Groundwater Remedy Phase 1 Construction, PG&E Topock Compressor Station, Needles, California

#### Work Variance Request #6 – Realignment of Pipeline F to Pipelines J and B

REVISED DRAWINGS FOR WORK VARIANCE REQUEST #6

Segments of Pipeline F  
to be realigned to  
Pipelines B and J

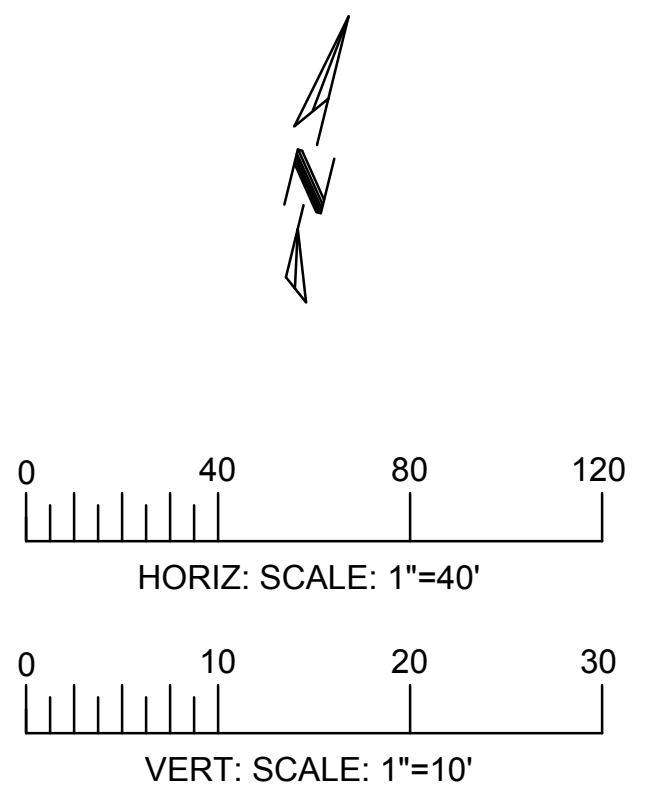
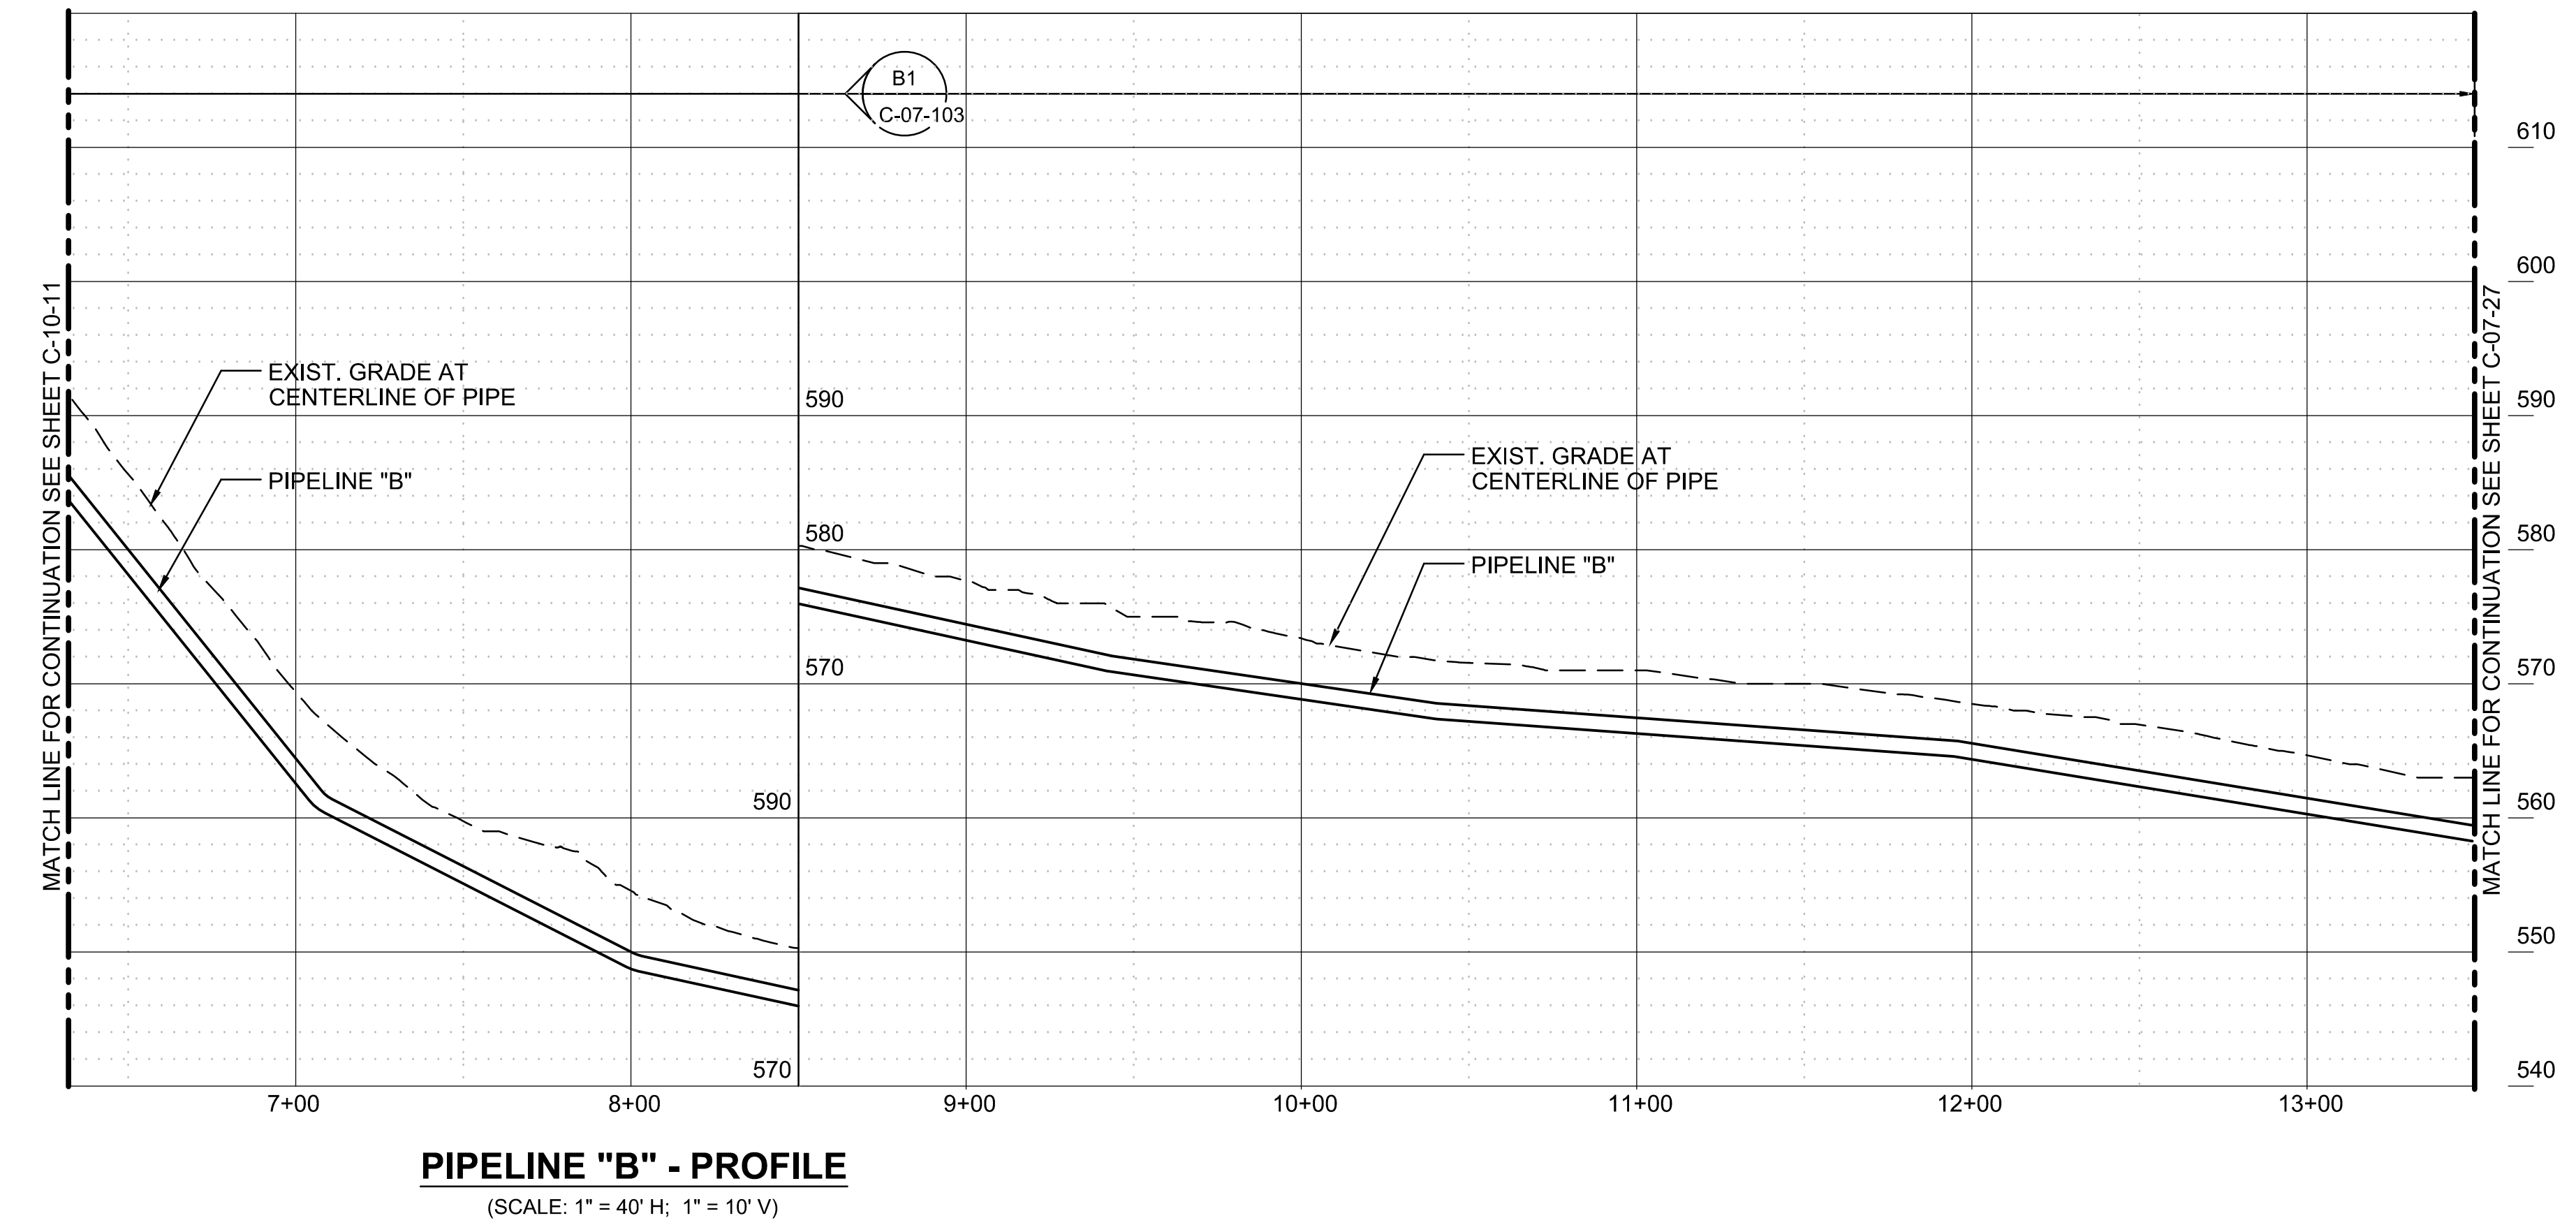
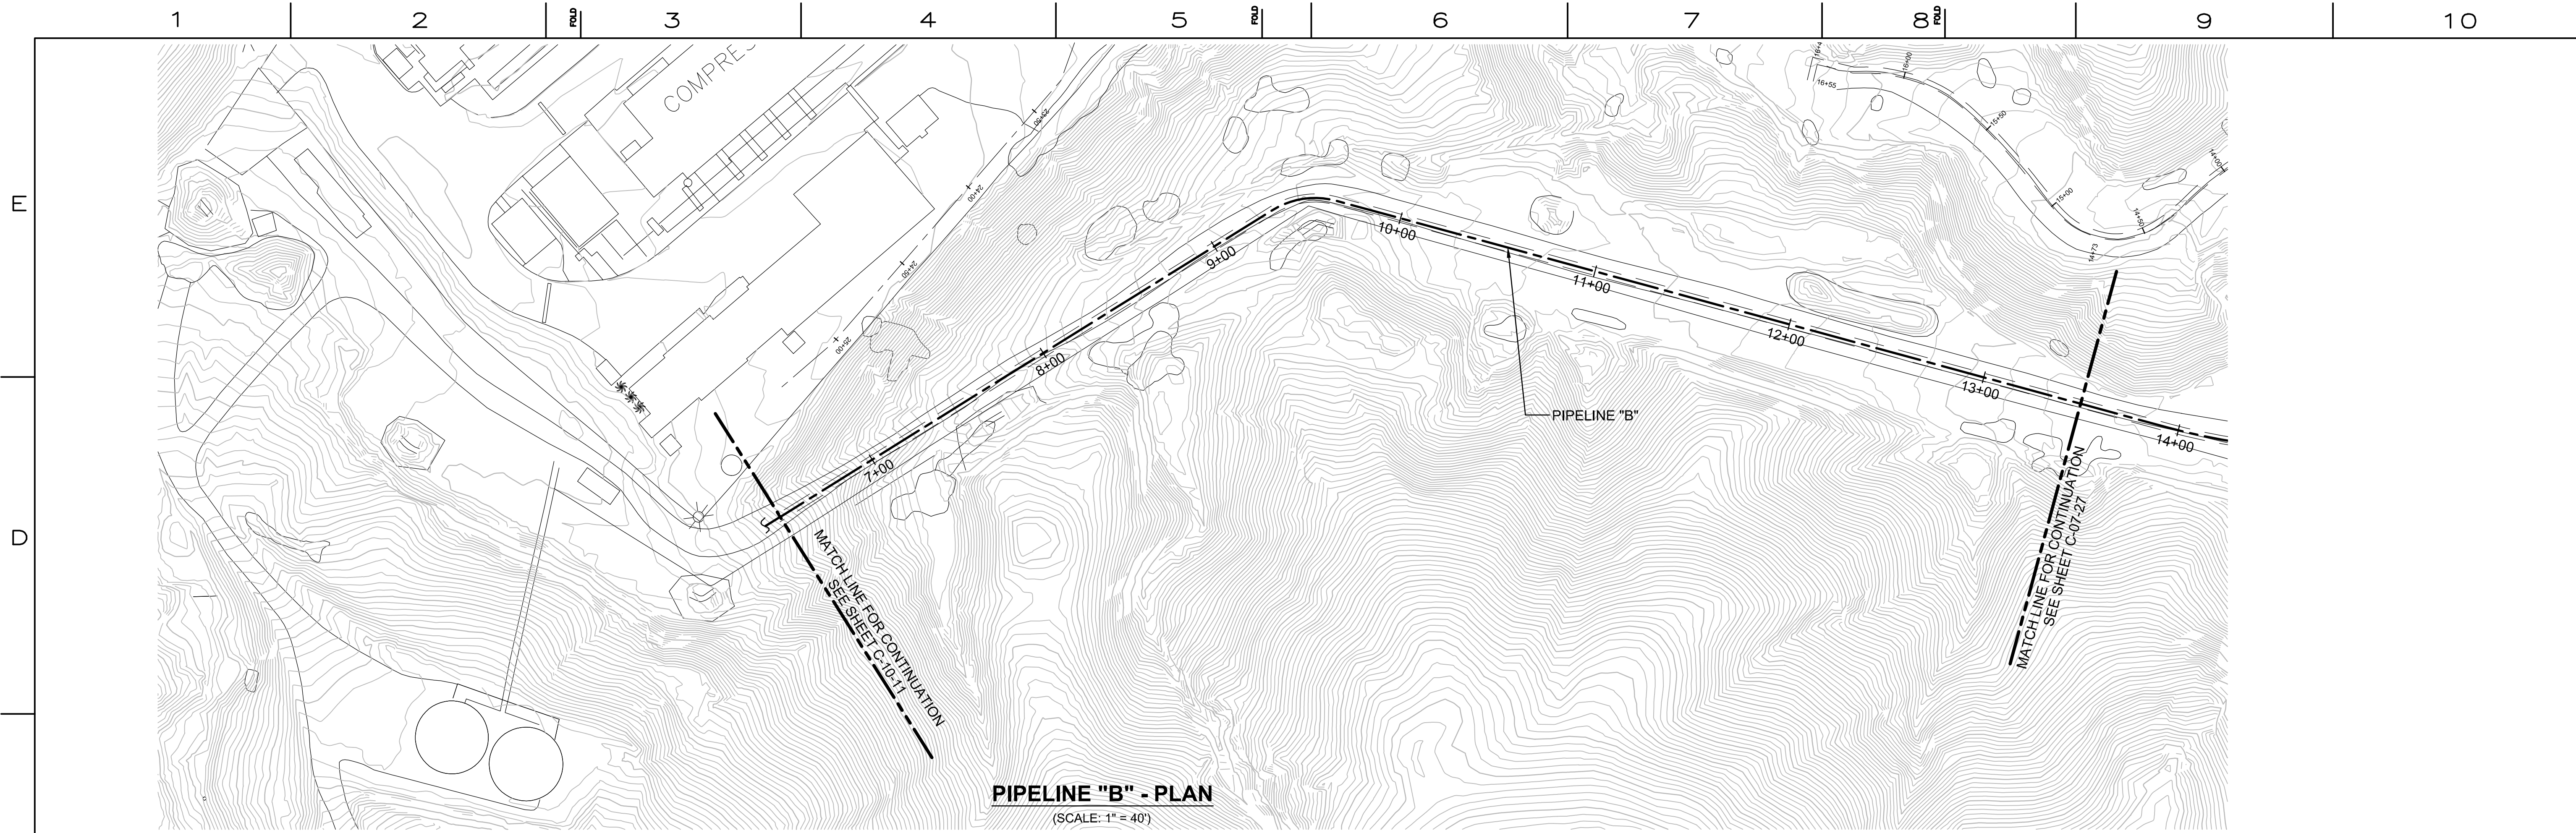
Therefore, PG&E proposes to realign Pipeline F (starting from segment F3) along the approved alignment of Pipelines B and J. Construction of Pipelines F, B, and J would occur in the same alignment and at the same time. The estimated net change in the excavated soil volumes and pipelines/conduits lengths are:

- Soil disturbance: a reduction of 1,590 cubic yards.
- Linear footage of trenches: a reduction of 1,250 feet.
- Linear footage of liquid conveyance piping: an increase of 7,832 feet (because the combined length of Pipelines J and B is 1,000 feet longer than Pipeline F)
- Linear footage of electrical conduits/communication lines: an increase of 979 feet (for same reason as above).

C-07-103 REV 6

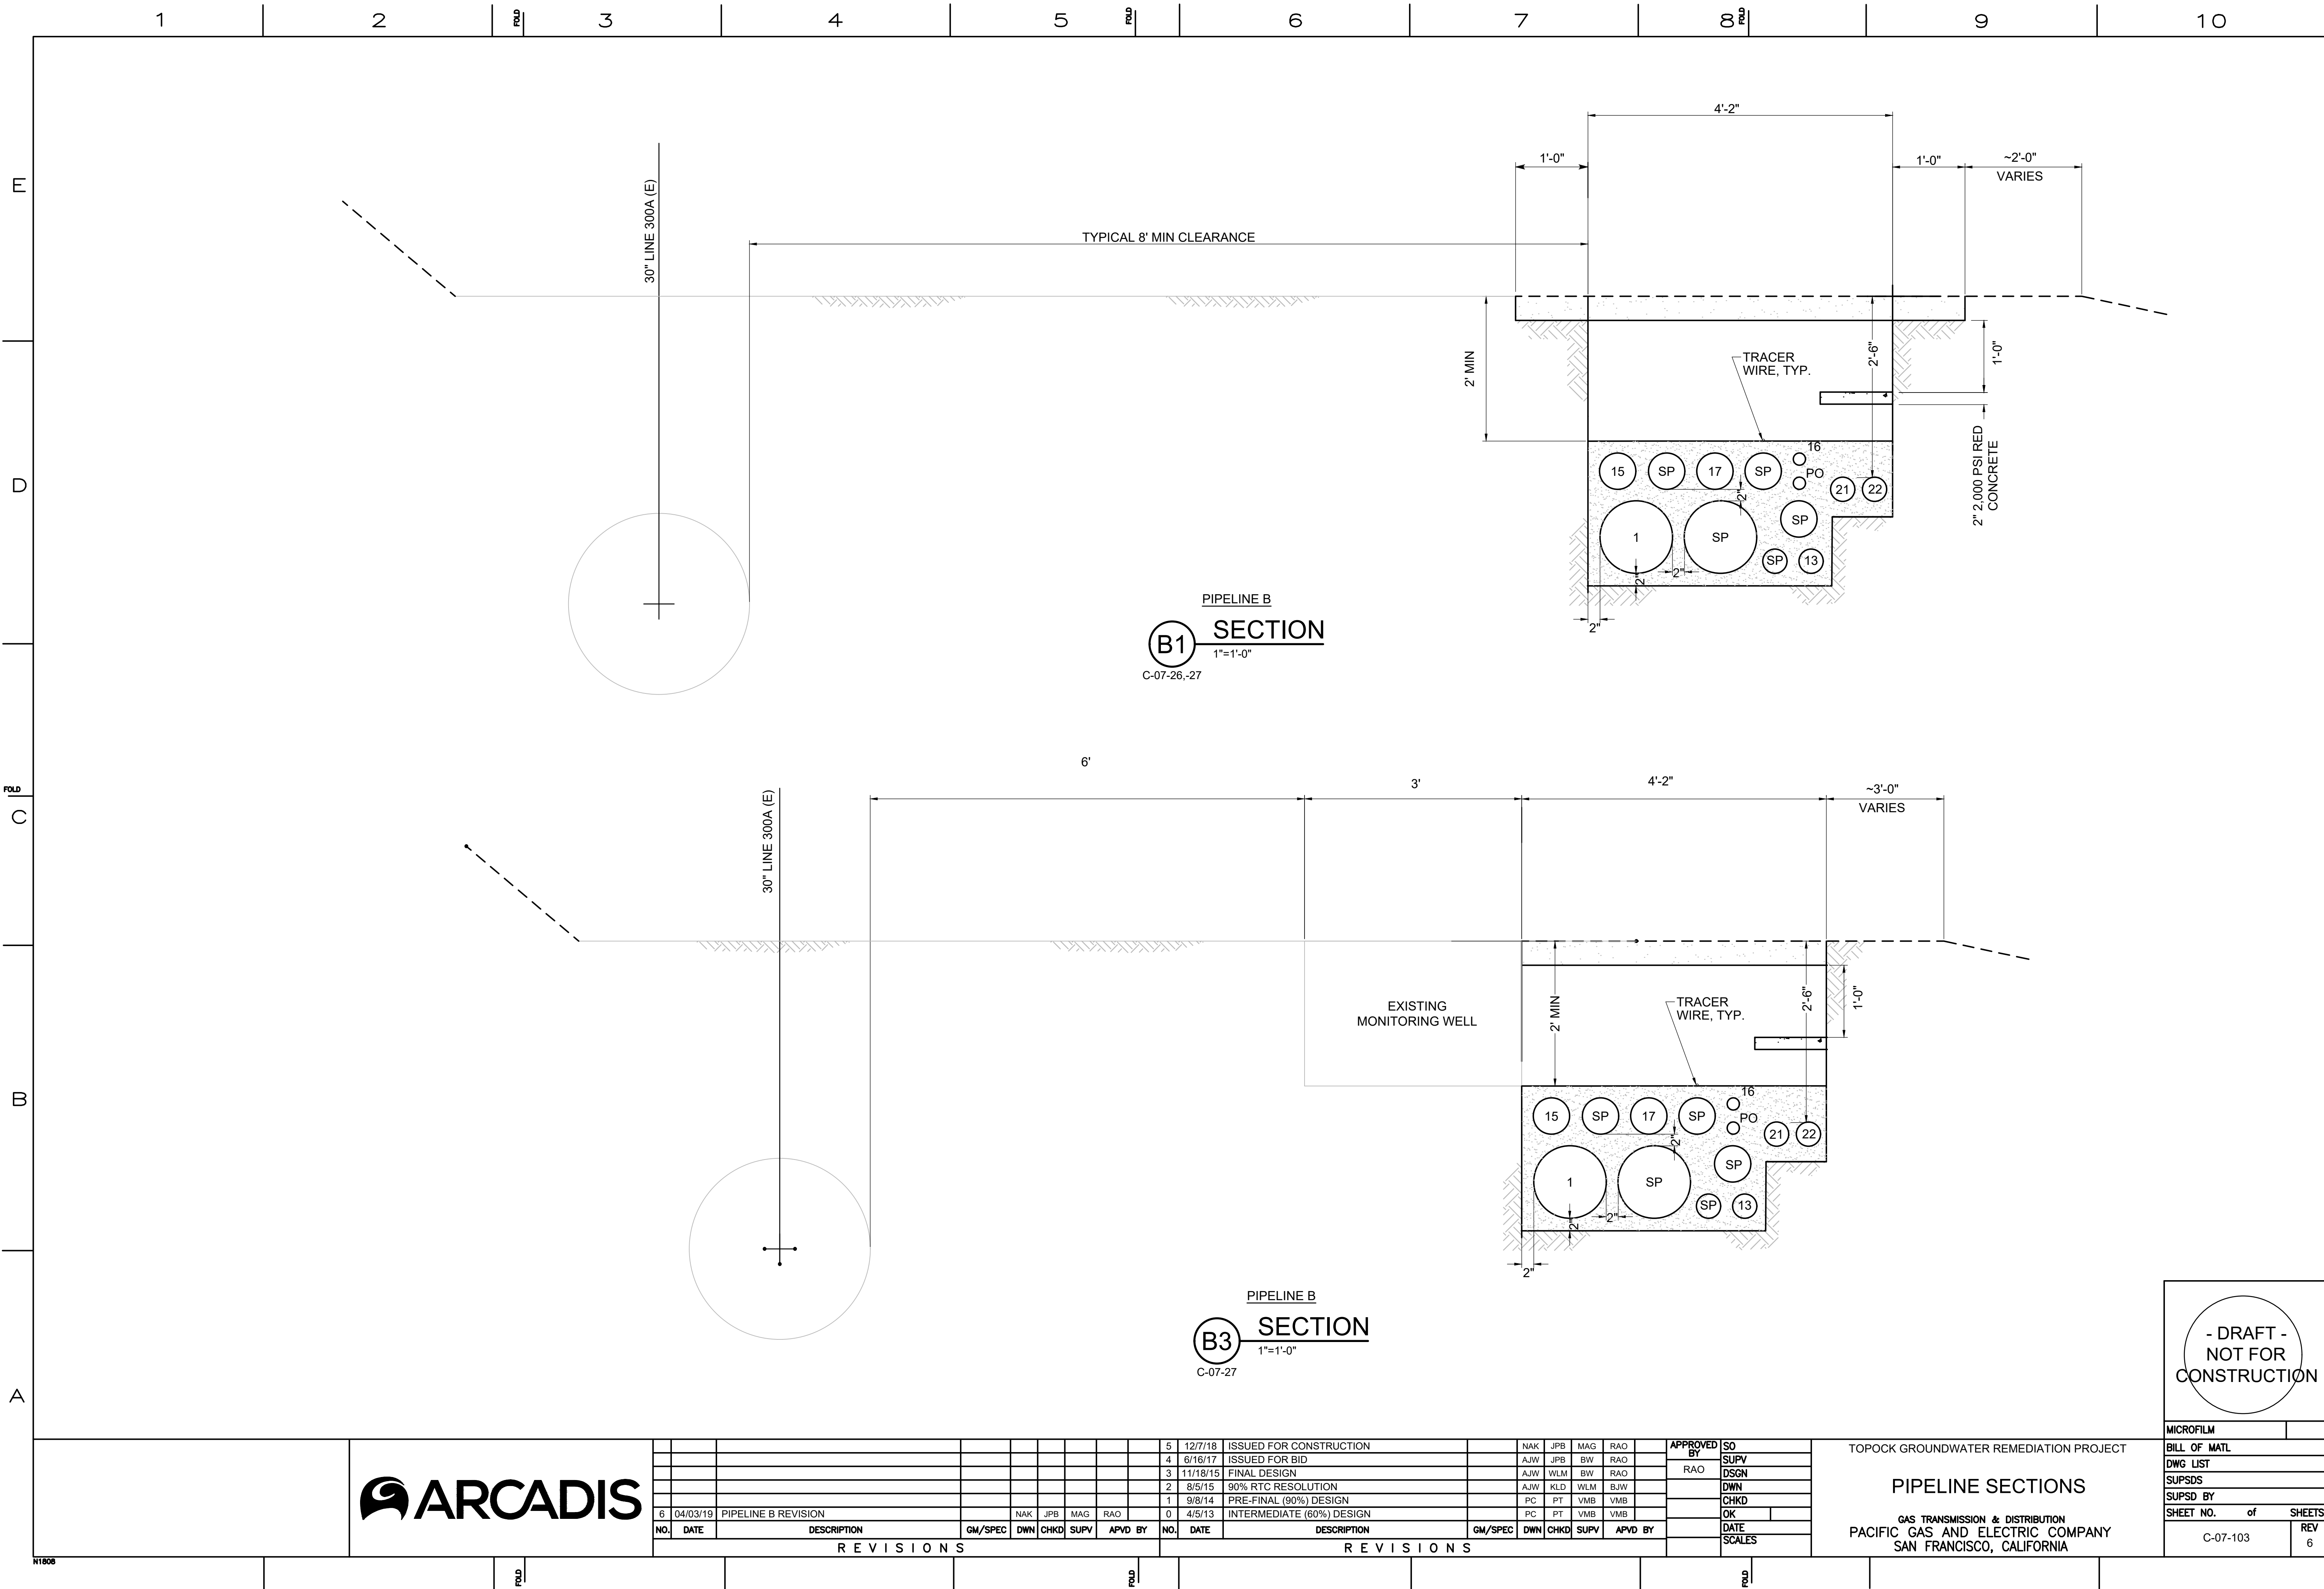
PIPELINE B  
**B1** SECTION  
1"=1'-0"  
C-07-26,-27

PIPELINE B  
**B3** SECTION  
1"=1'-0"  
C-07-27
